Location:	6501 Shattuck Avenue- See map on reverse
Assessor's Parcel Number:	016 142801102
Proposal:	Two Appeals of the Zoning Manager's Approvals: 1) to construct a 4-story mixed-use building with commercial space and parking on the ground floor and 18 residential units above; and 2) for two additional required permits for a Multifamily Dwelling Residential Facility and more than 20% of the required group open space on the roof which were not included on the previous public notice or original Decision Letter.
Applicant:	Moshe Dinar (510)759-2133
Owner:	Bruder, LLC
Appellant:	Appellant 1) Chris Hall Appellant 2) Caitlin Stuart
Case File Number:	APL19003 and APL20010
Original Case File Number:	CDV10185
Planning Permits Required:	Interim Conditional Use Permit for a density of 18 residential units where the General Plan allows for 31 units and the zoning only allows for 5 units; Minor Conditional Use Permit for a Multifamily Dwelling Residential Facility and parking to be setback less than 75 feet from the front property line, Regular Design Review for new construction; and Minor Variances to allow a 13-foot high garage podium structure to project 7 feet into the required 15-foot rea

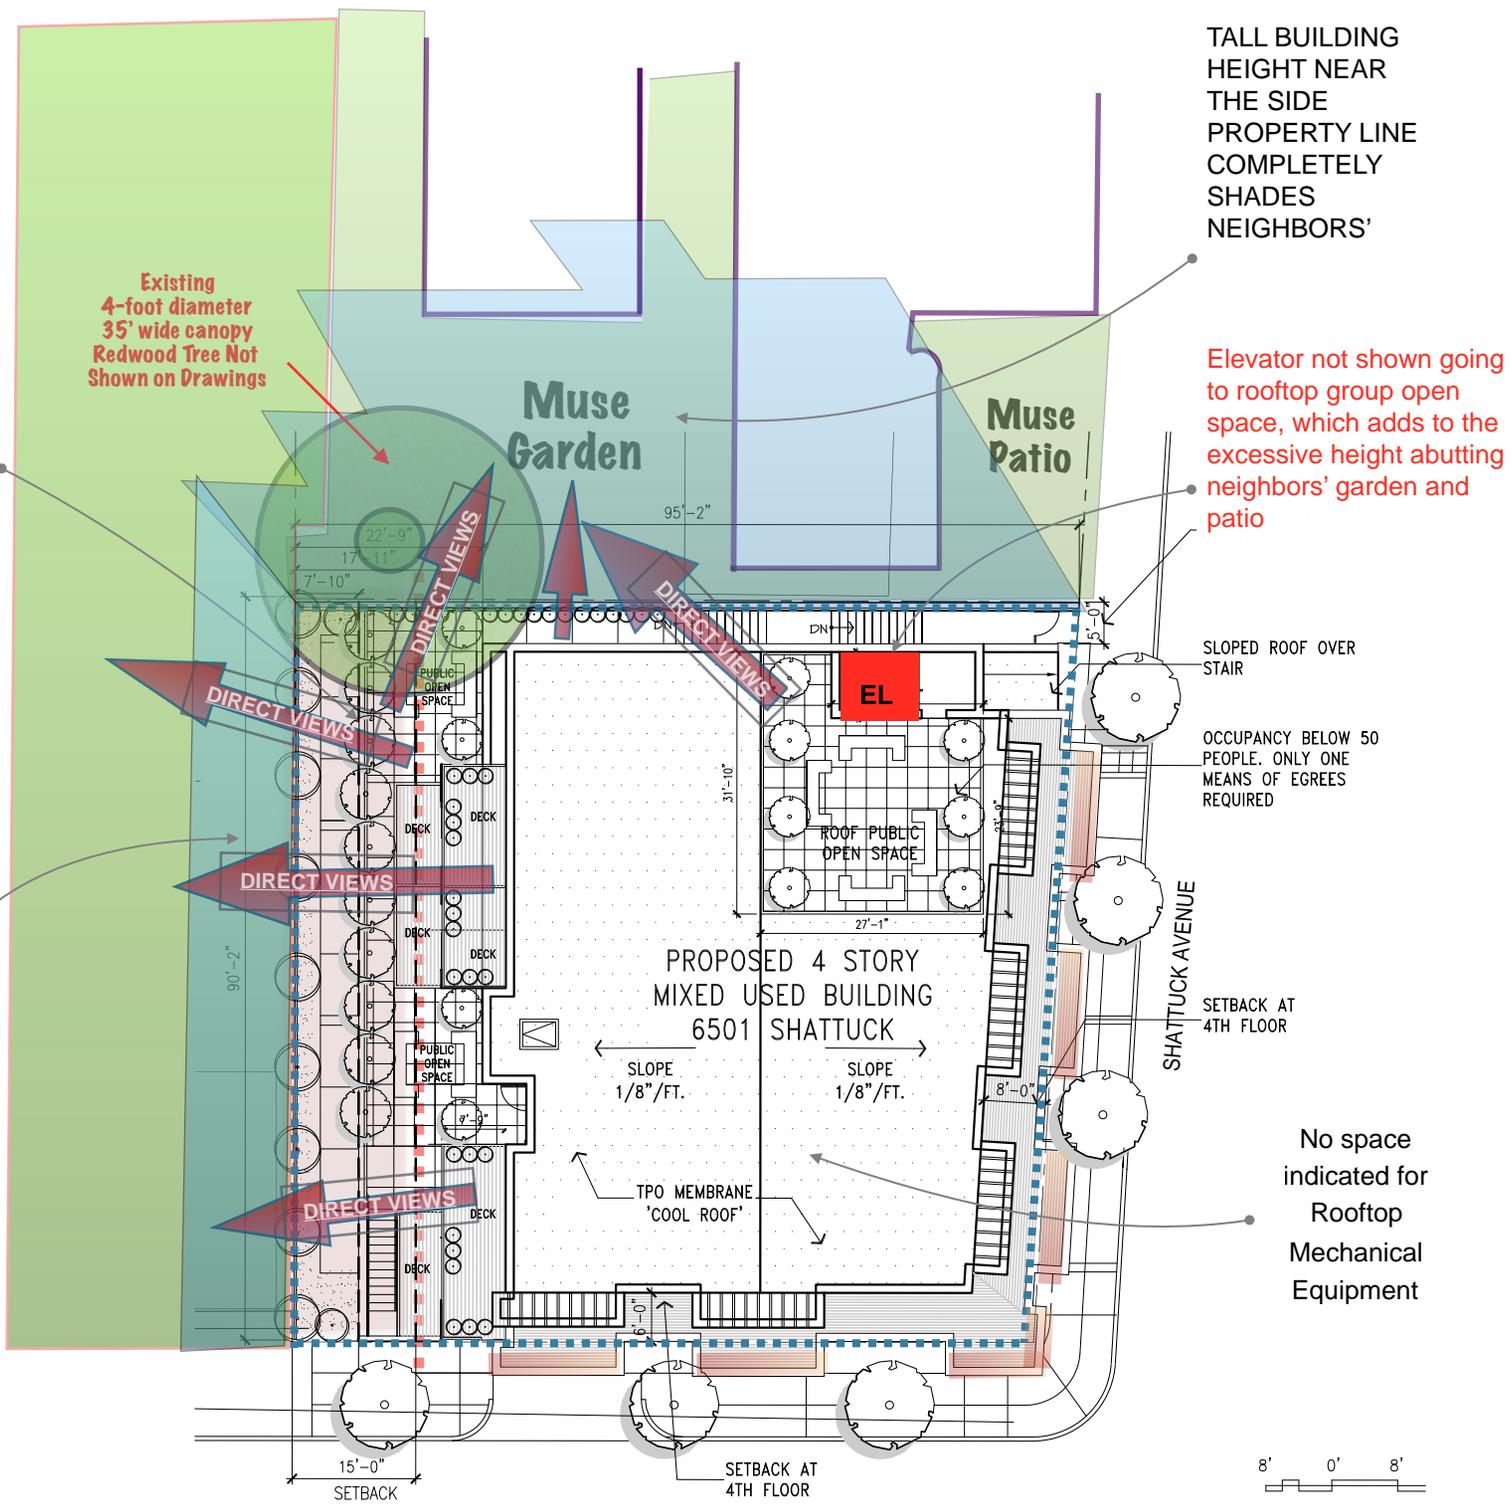
Inadequate space for bike storage

Building projections over the Property Line & narrow sidewalk leave No space for canopy of street trees

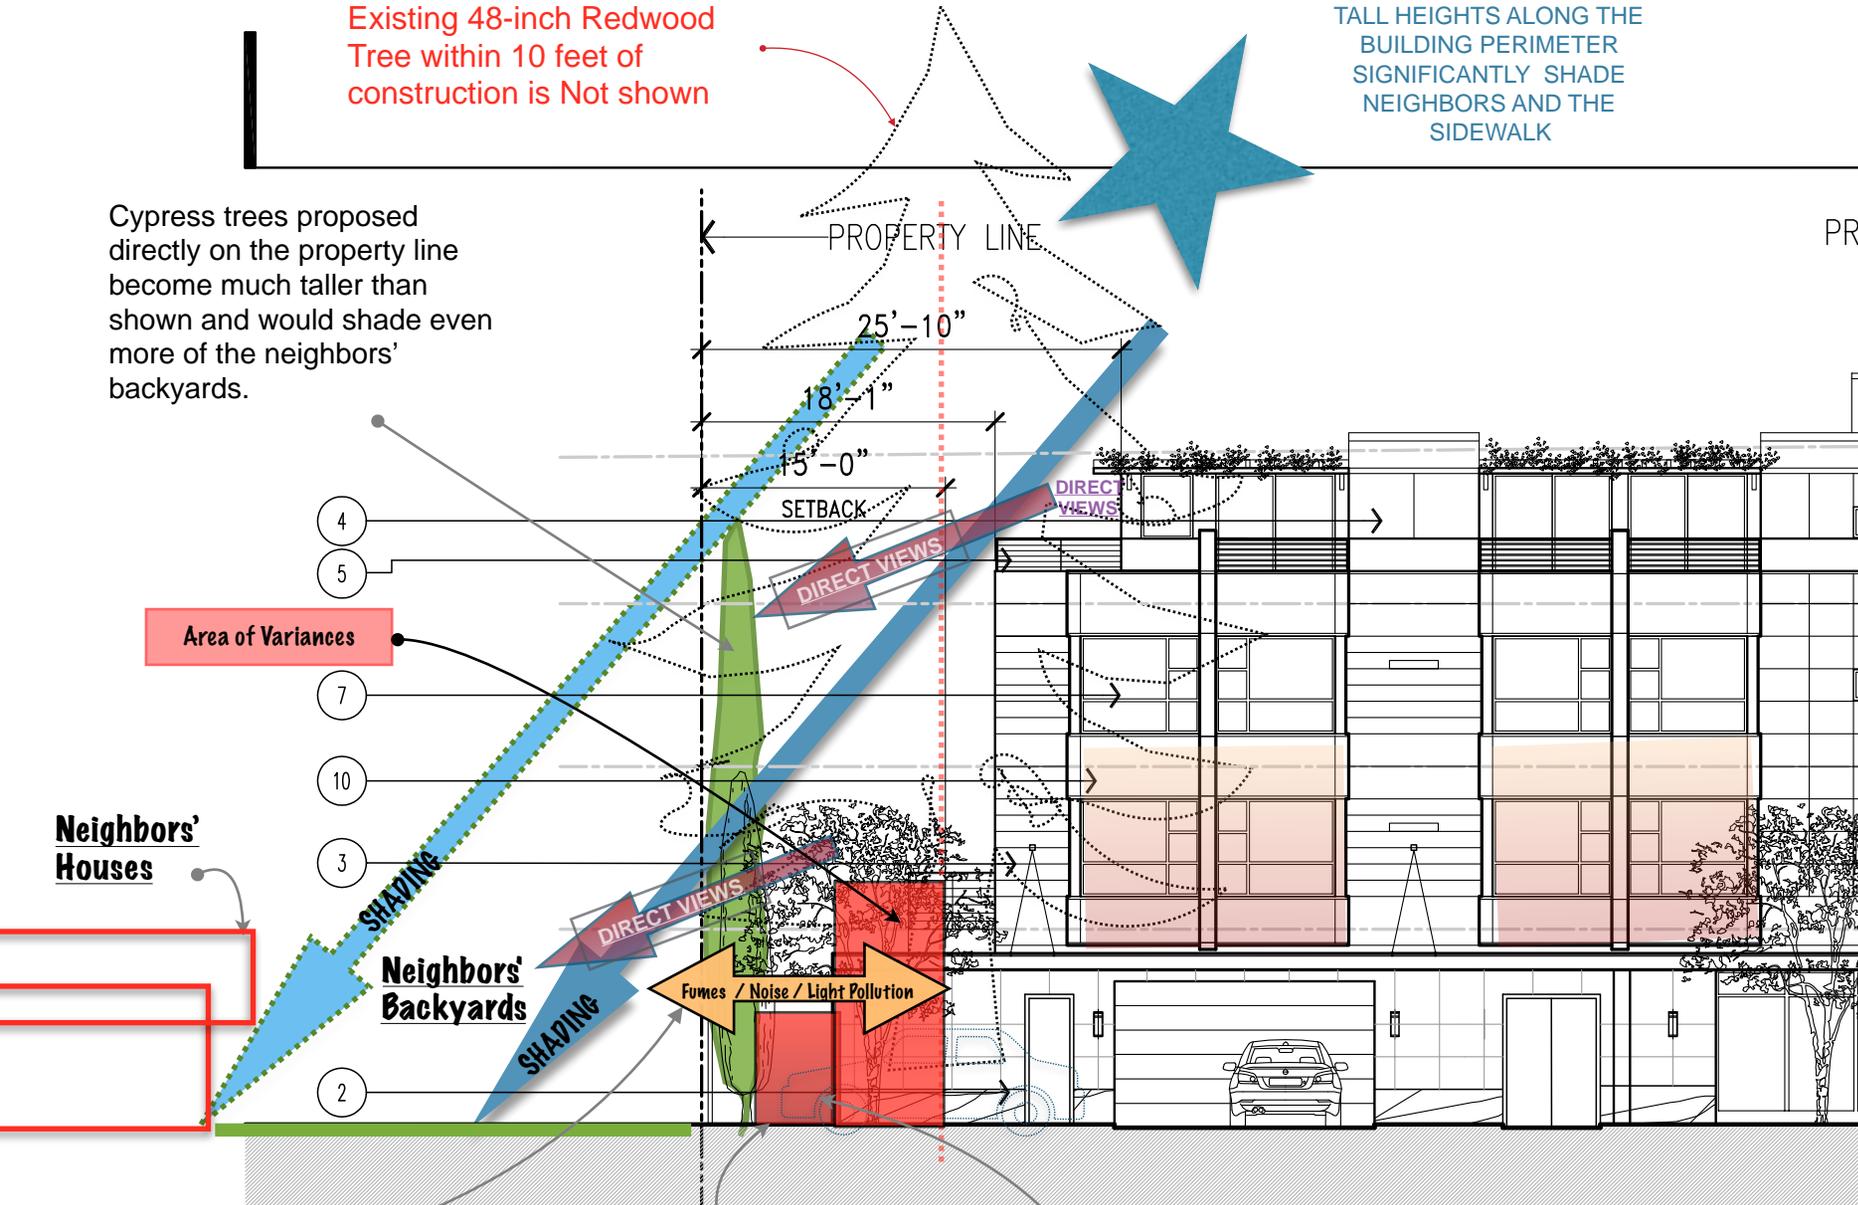
TALL HEIGHTS ALONG THE BUILDING PERIMETER SIGNIFICANTLY SHADE NEIGHBORS AND THE SIDEWALK

Cypress trees proposed directly on the property line become much taller than shown and would shade even more of the neighbors' backyards.

CLOSE UP OF 65TH STREET ELEVATION - (SEE PAGE 5 FOR FULL ELEVATION)

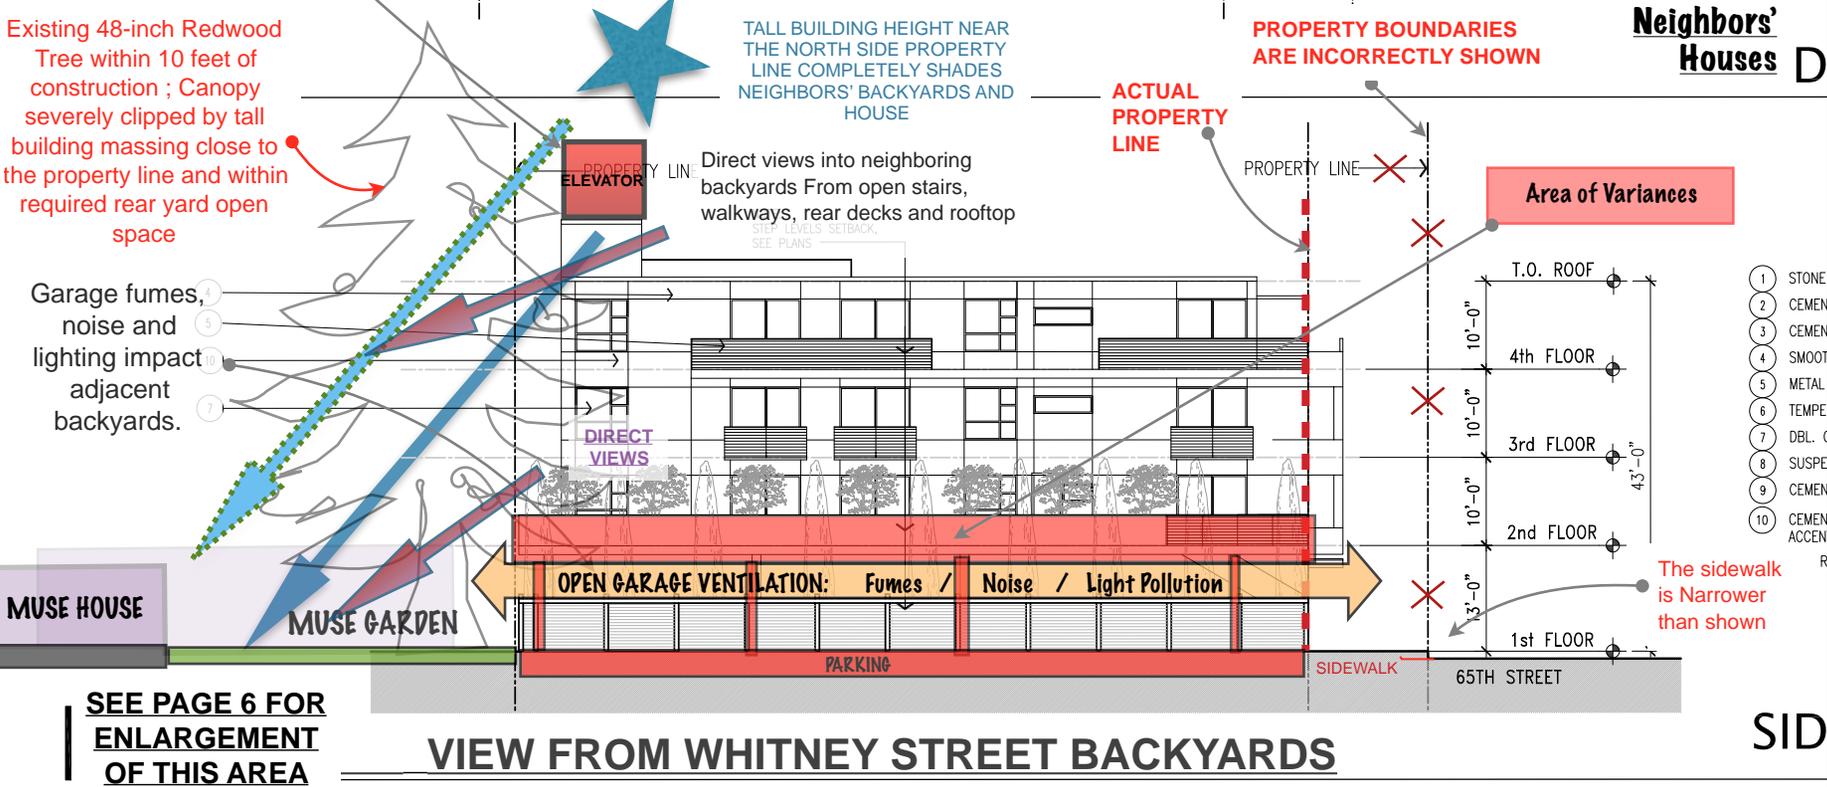
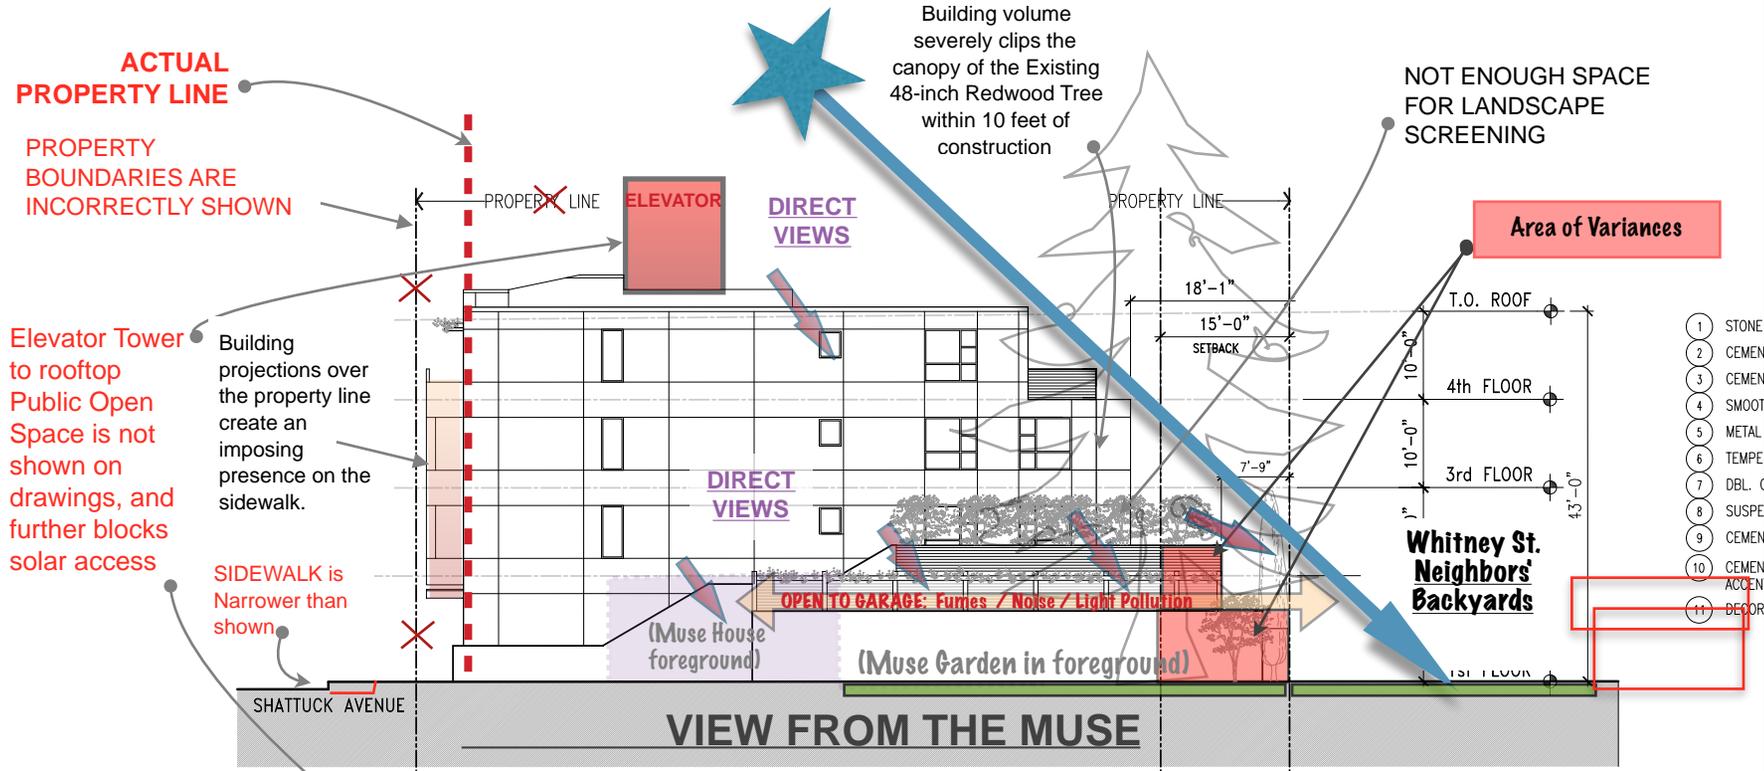
Cars encroach into required setbacks, leaving no room for landscaping

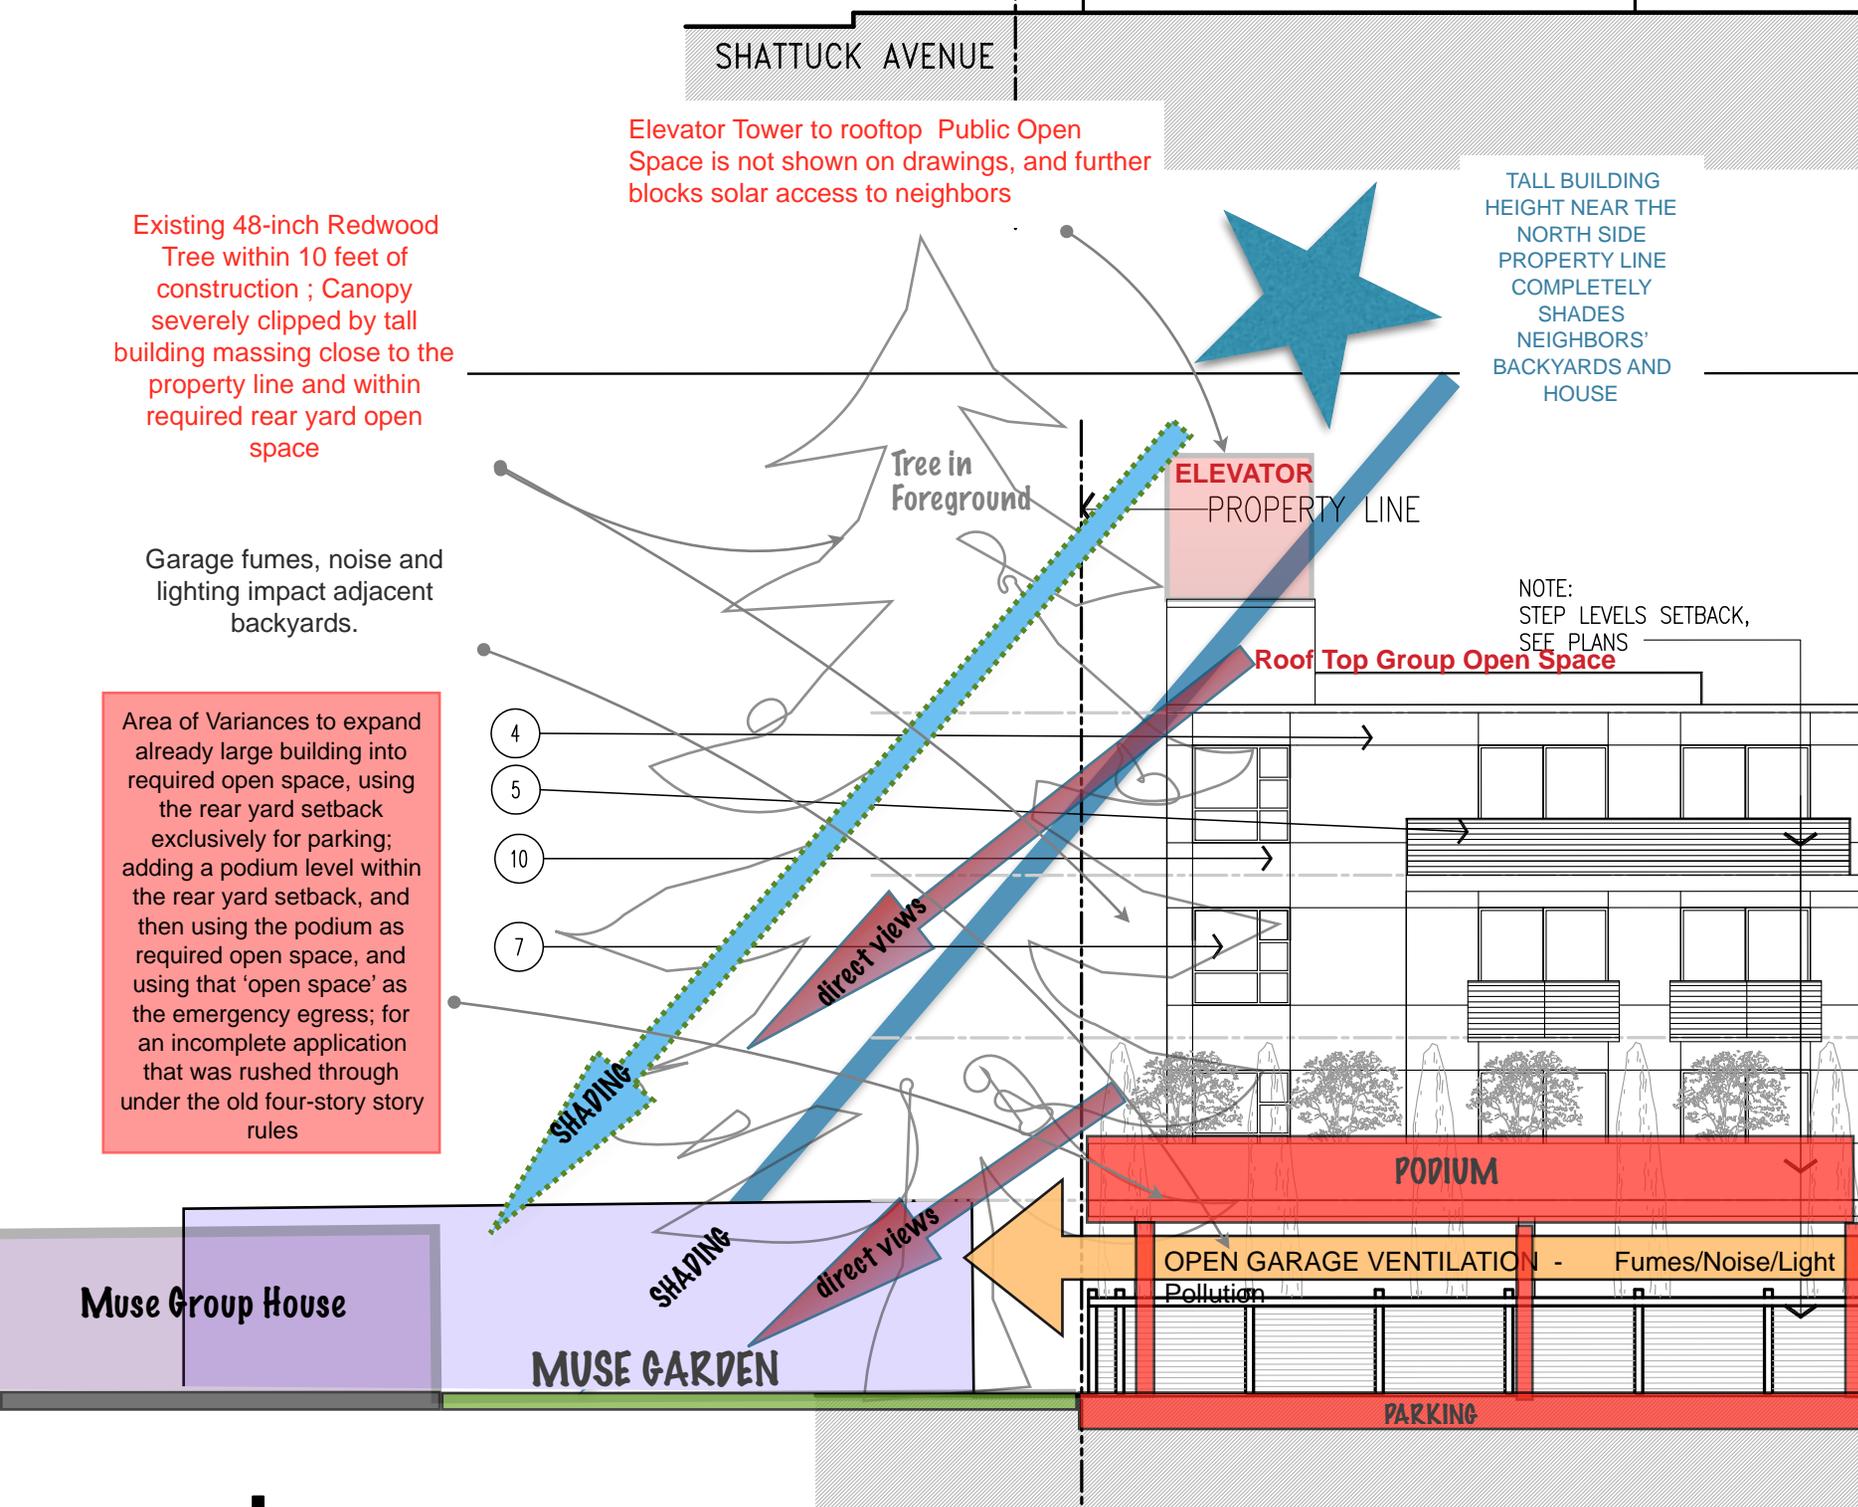
TALL BUILDING HEIGHT NEAR THE NORTH SIDE PROPERTY LINE COMPLETELY SHADES NEIGHBORS' BACKYARDS AND HOUSE

NOTE: STEP LEVELS SETBACK, SEE PLANS
